Determination 2016/026

Determination regarding the compliance of a vapour barrier to a proposed pool house at 867 Rapaura Road, Blenheim

Summary

Figure 1: General roof / wall construction (not to scale)

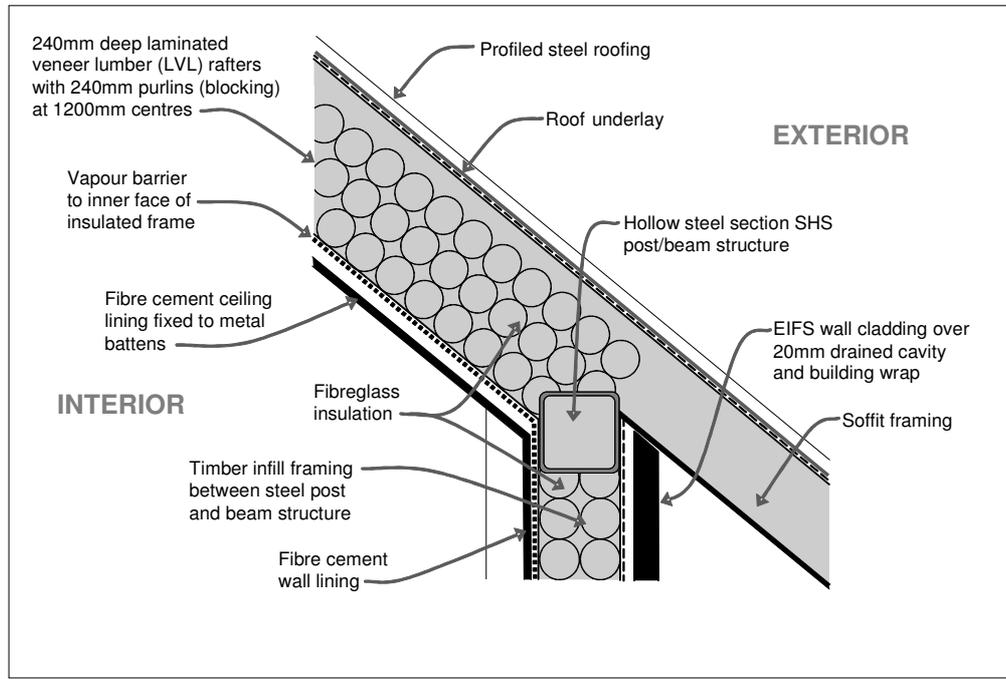
- 6.2.1 The purpose-made vapour barrier provides the primary means of preventing water vapour entering the building envelope. The wall and ceiling linings (which are to be flush-jointed and painted with all penetrations sealed) are considered, by the designer, a ‘backup’ to the vapour barrier. Insulation takes the form of fibreglass batts installed between timber wall and ceiling framing.

- 6.2.2 The installation of the vapour barrier is critical to prevent the passage of water vapour from passing into the building envelope, and requires careful attention to the installation of linings, services, the detailing of junctions and joinery openings. Any fixings to the wall and ceiling linings will puncture the vapour barrier, at which point the vapour barrier’s performance is compromised.

- 6.2.3 The designer has said that fixings will form a negligible proportion of the area of the barrier, and fixings will be into the timber framing preventing vapour transmission. I note in the case of the galvanised mild steel ceiling battens, no such seal can be formed between the ‘hollow’ underside of the batten and the ceiling framing.

- 6.2.4 The successful use of the vapour barrier places heavy reliance on the prevention of cold bridging to prevent condensation; cold surfaces allow the formation of condensation. The proposed design presently contains thermal bridges, being: the inside faces of steelwork, which would require insulation in addition to a vapour barrier; and the skylights. The building elements must therefore be sufficiently durable to allow for the condensation that is likely to form. I note the ceiling lining is located on proprietary galvanised mild steel ceiling battens faced fixed to the ceiling framing. It is not clear how durable the steel battens will be when used in this situation.

- 6.2.5 The proposed solution is fully reliant on the skill and diligence of the installer. In my view the construction details shown in the drawings do not adequately describe how the building envelope is to be protected from the ingress of internally-generated water vapour.

- 6.2.6 An option open to the designer is to apply suitably-treated timber battens over the vapour barrier installed to the wall and ceiling framing, with the battens sealed at each point of fixing to the framing. With the integrity of the vapour barrier protected, the linings can be installed with less attention to sealing, and the like. I note also that gaps at the top and bottom of the linings may assist in mitigating ‘sweating’ behind linings should cold bridges be present. I note that linings using insulated panels with an ability to withstand high humidity may also offer a more robust solution. These design options are not to be taken as a decision by the determination that they will provide a compliant solution: any proposal must be based on a fully detailed solution provided to the authority for its consideration.
